7801 Atlantic Way

City of Miami Beach
Last Completed Item Reviews Across All Submittals

RESPONSE TO COMMENTS

Permit Number: **RV2114494**
Address: 7801 Atlantic Way
Miami Beach, FL 33141

SHEET:
3 OF 3

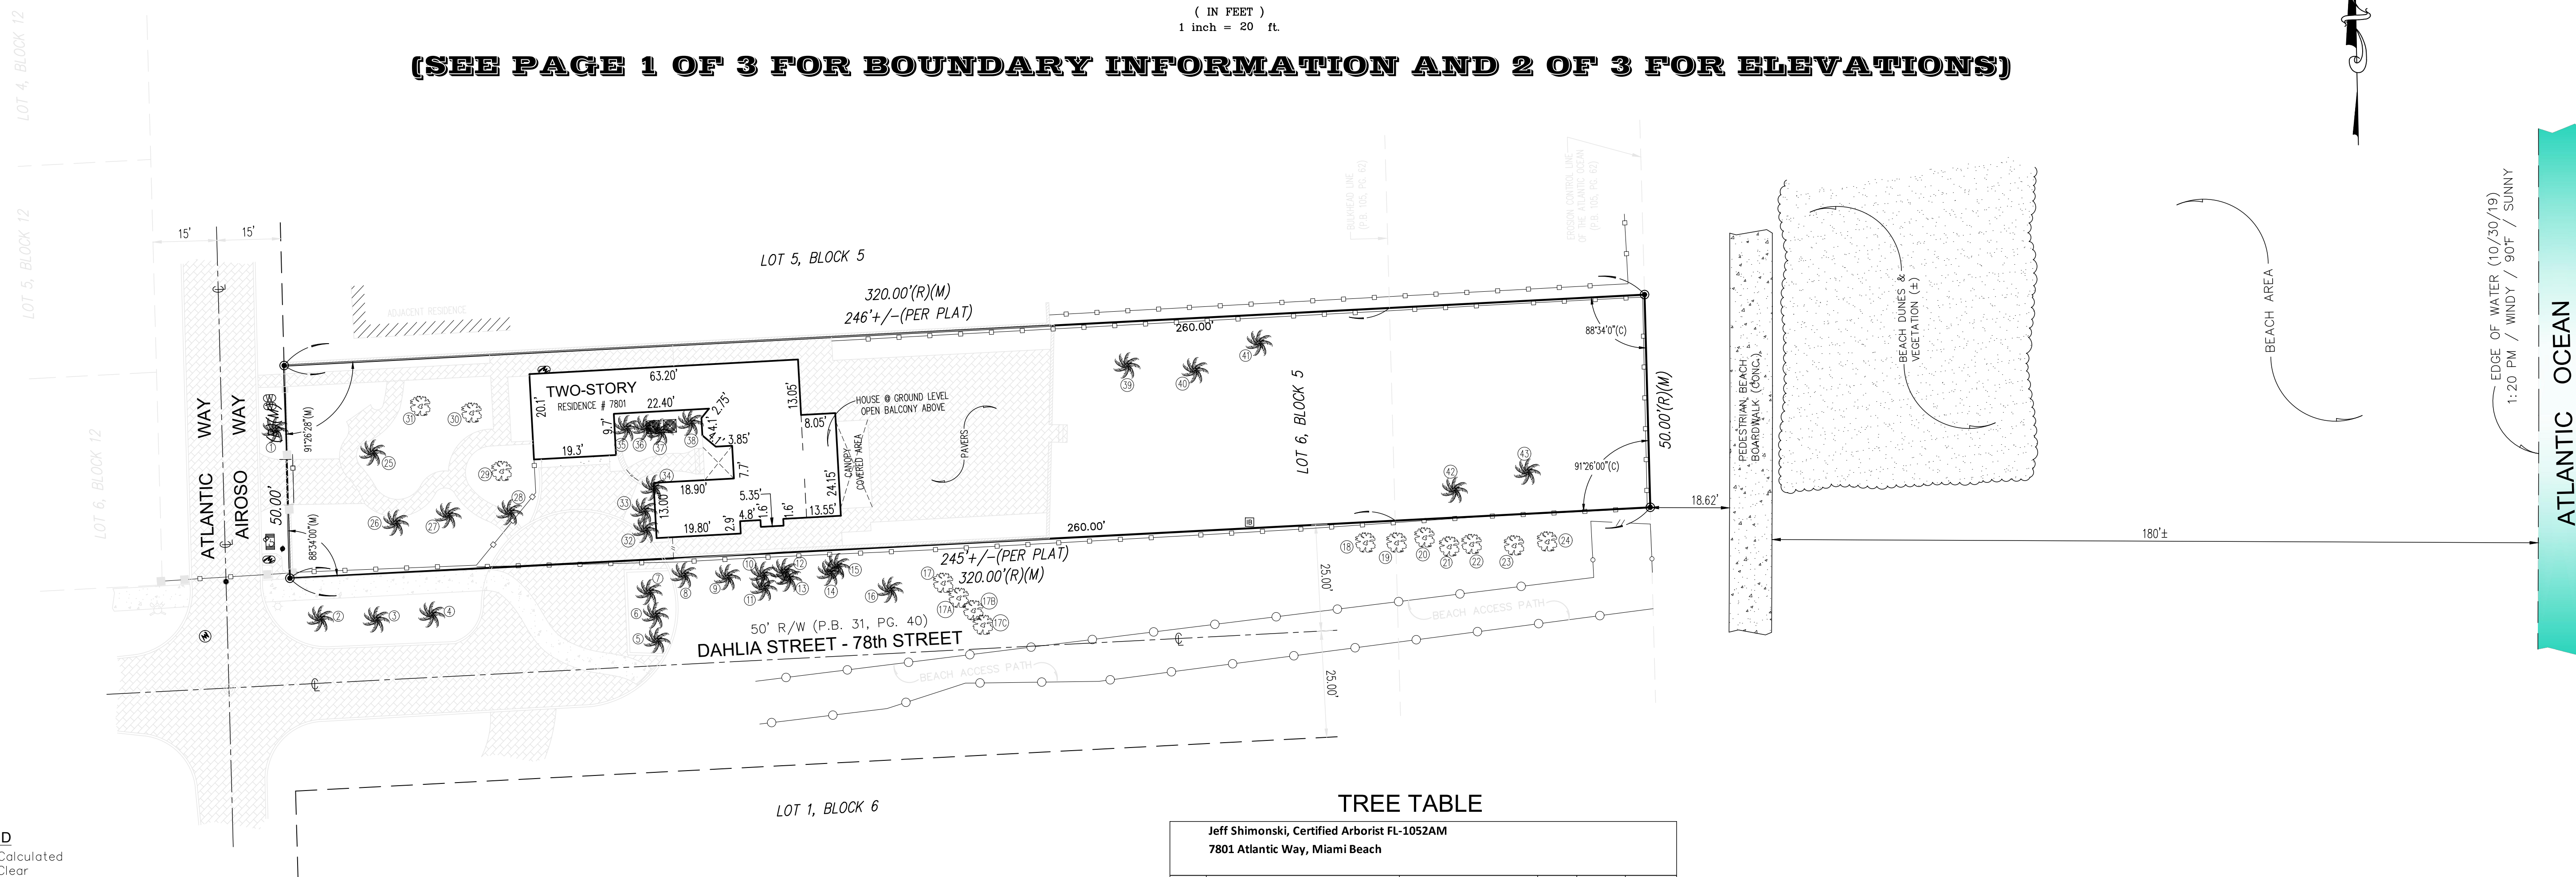
Provide a Tree Survey prepared by a Professional Land Surveyor listing the common names, sizes, and locations of existing trees and palms with a DBH of 6" or greater. If removal of trees is required, please provide a Tree Disposition Plan. Removal of any non-invasive trees with a 6" DBH or greater from private property would require a Tree Removal Permit from CMB Urban Forestry. Removal of any non-invasive trees with a 3" DBH or greater from public property would also require a Tree Removal Permit from CMB Urban Forestry

RESPONSE: REFER TO FILE NAME: JN 19-5113 B PAGE 3 OF 3 (1).PDF FOR TREE SURVEY INCLUDING THE LOCATION FOR ALL EXISITNG TREES, PALMS AS WELL AS DBH INFORMATION AND CANOPY. TREE REMOVAL IS NOT REQUIRED AS NO TREES ARE AFFECTED. THIS REVISION PERTAINS TO THE EXISTING PATHWAY CONNECTING DRIVEWAYS. INCLUDED TREE PROTECTION PLAN WHICH INCLUDED IN MASTER SET FOR REFERENCED.

sheet no. TP-1

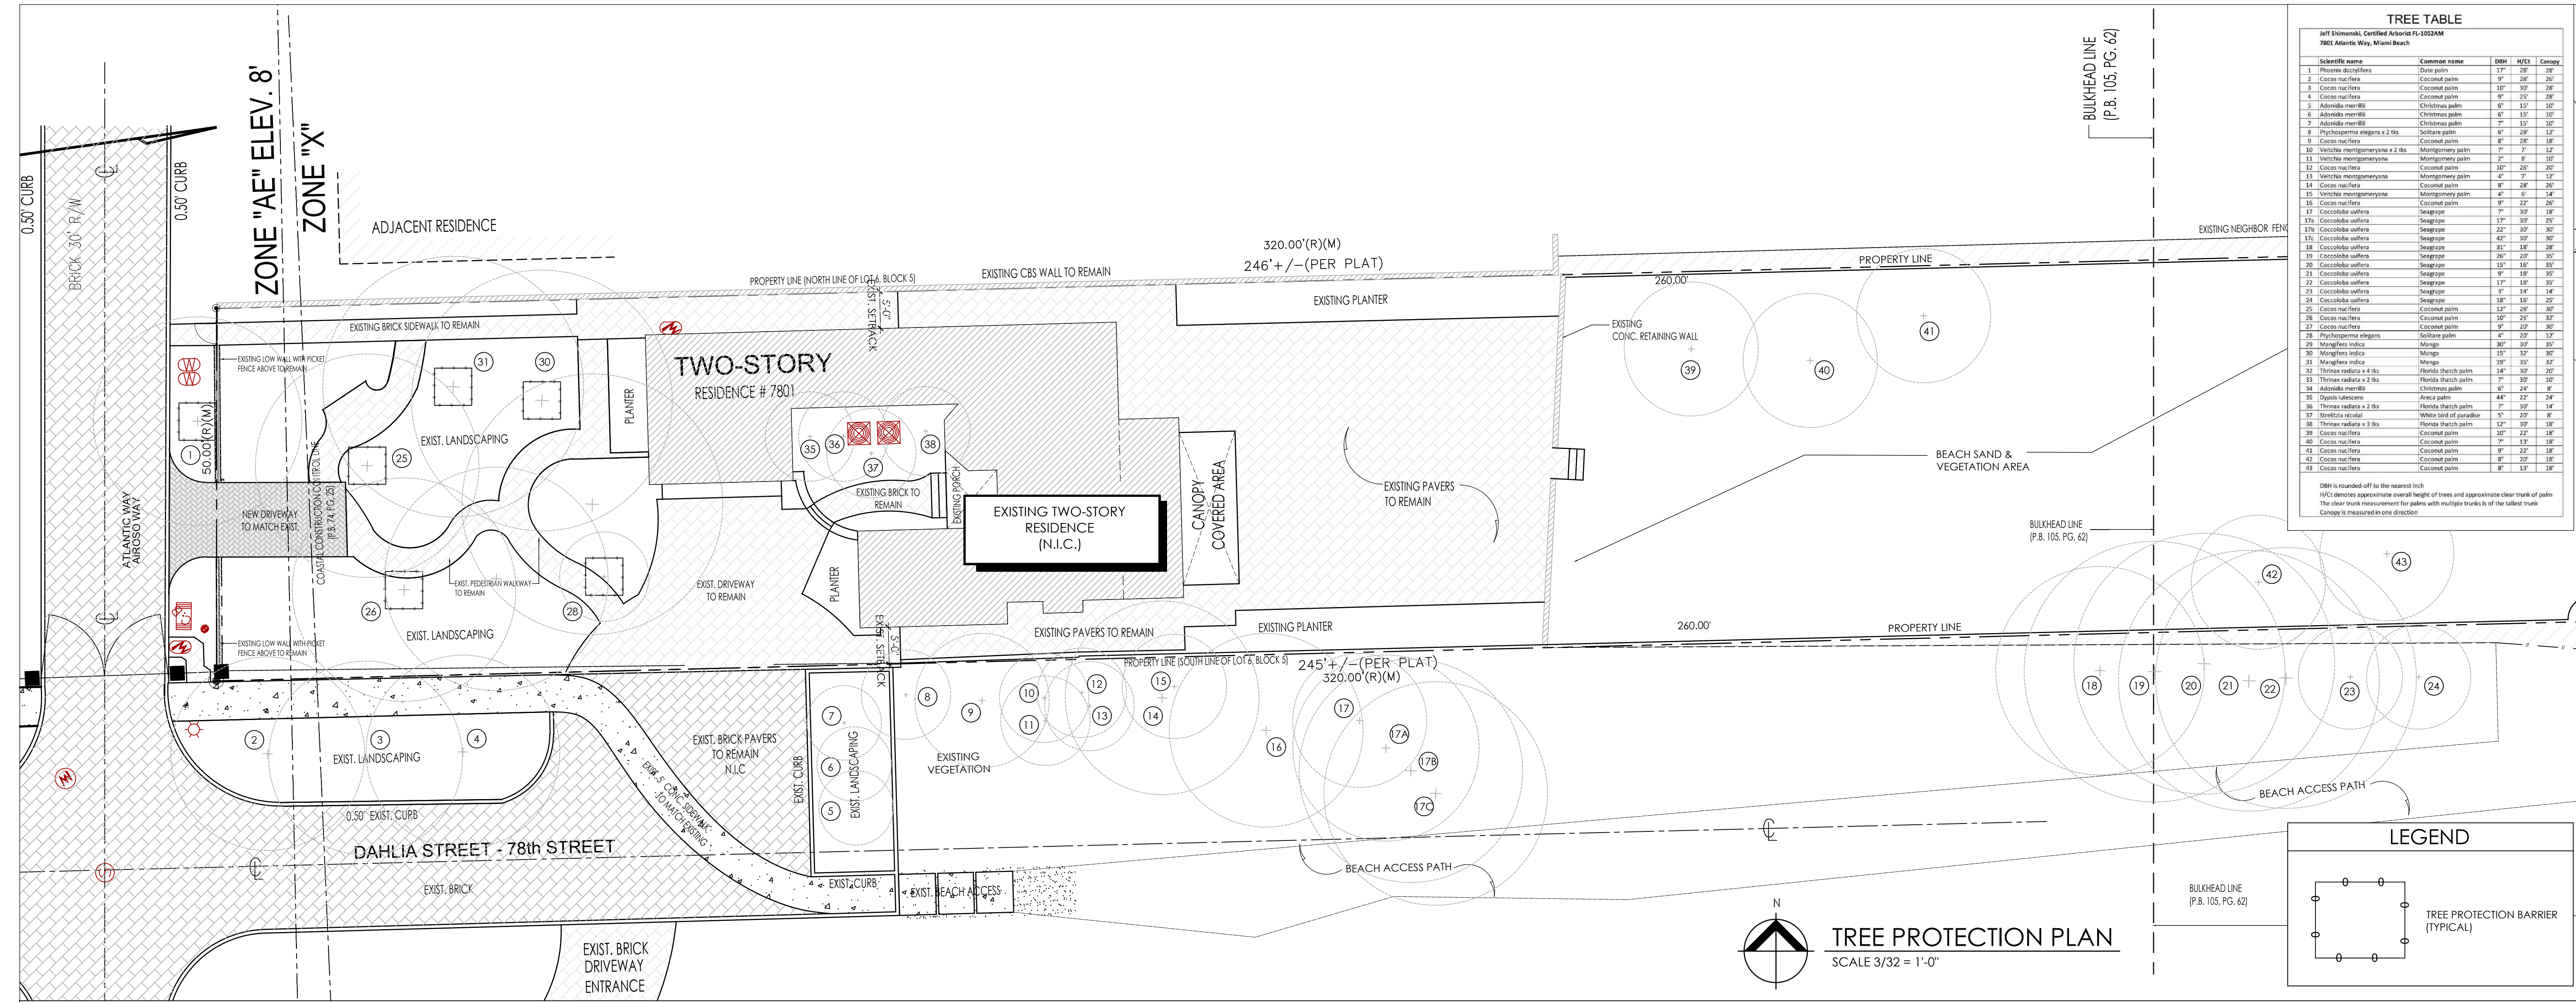
Proposed work could come in direct conflict with existing trees/palms. Please include a tree survey drawn to scale identifying the species and listing the height, spread and DBH of all existing trees/palms. The tree survey shall be prepared by and bear the seal of a professional land surveyor, licensed in the State of Florida. In addition, a tree disposition and site plan drawn to scale identifying and listing all existing trees/palms and specifying the condition of each tree and whether such trees/palms are to remain, to be removed or to be relocated shall be provided. This plan shall also illustrate the location of all existing structures and/or all proposed new construction, as applicable, the location of any overhead and/or underground utilities, the new locations of existing trees/palms to be relocated on site, and all areas affected by construction-related activities, such as access routes to the property, and staging area. The plan shall be prepared by and bear the seal of a landscape architect currently licensed to practice in the State of Florida. If you have any questions or concerns please contact us at urbanforestry@miamibeachfl.gov Please provide us with your process number and contact information and we will get back to you within 48hrs.

RESPONSE: REFER TO FILE NAME: JN 19-5113 B PAGE 3 OF 3 (1).PDF FOR TREE SURVEY INCLUDING THE LOCATION FOR ALL EXISTING TREES, PALMS AS WELL AS DBH INFORMATION AND CANOPY. TREE REMOVAL IS NOT REQUIRED AS NO TREES ARE AFFECTED. THIS REVISION PERTAINS TO THE EXISTING PATHWAY CONNECTING DRIVEWAYS. INCLUDED TREE PROTECTION PLAN WHICH INCLUDED IN MASTER SET FOR REFERENCED
